Road Safety Audit Report

Incorporating
Stage 1 Completion of Preliminary Design.

Proposed Access off the A259 New Road, Rustlington

REDW-3167

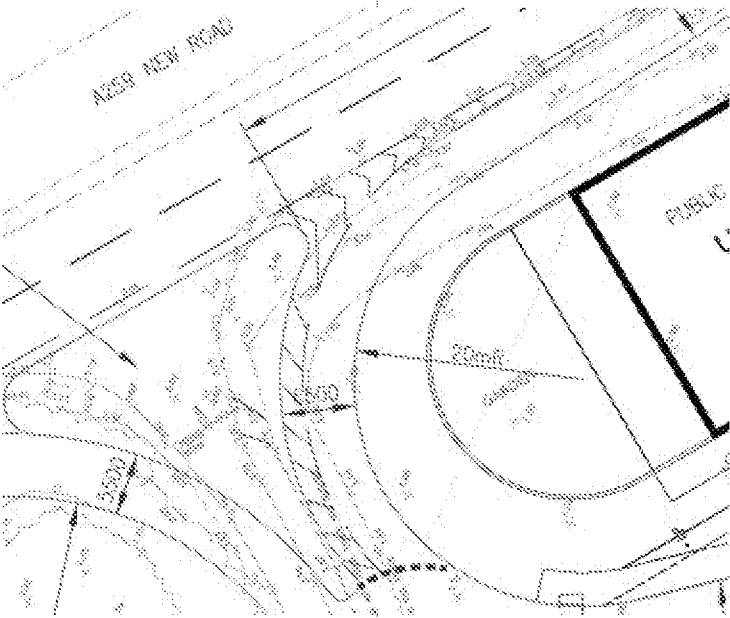
A.2	LOCAL ALIGNMENT	
A.2.1	PROBLEM Tight entry corner radius Accident Type <i>Loss of Control</i> Location Entry radius from deceleration lane <i>The proposed deceleration lane is provided for vehicles to decelerate from the derestricted A259. Vehicles could therefore be travelling in excess of the speed required to safely manoeuvre around the 20 metre corner radius. This could result in vehicles losing control and striking the island.</i> The appropriate chevron and warning signs should be installed in clear view of vehicles utilising the deceleration lane to ensure that drivers are aware of the corner. 	Chevron sharp deviation of route signs (Diag. 515) have been included on the central approach island as shown on Drg.No. REDW-3167-110-Rev A

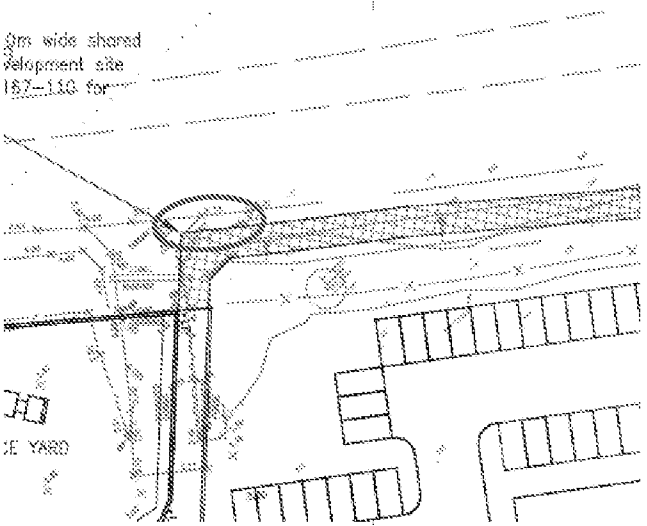
Audit Item No.	Audit Team Observation	Audit Team Recommendation	Designer / Scheme Response
A.4.2	PROBLEM Footway / Cycleway link guides into A259 carriageway Accident Type <i>Vehicle/Pedestrian, Cyclist Collisions</i> Location East of service yard The footpath/cyclepath link that is proposed, heads in a northerly direction adjacent to a service yard and bends 90° to a facility that is to run alongside the A259 carriageway. The 90° bend could result in cyclists losing control and pedestrians travelling into the path of vehicles on the A259. 	A section of guard railing should be introduced to ensure that non-motorised users follow the line of the footway/cycleway and do not enter the A259 carriageway.	A section of guardrail will be included at the detailed design stage. The guardrail will prevent non-motorised users from entering the A259 carriageway.
A.5	ROAD SIGNS, CARRIAGEWAY MARKINGS, LIGHTING AND DRAINAGE
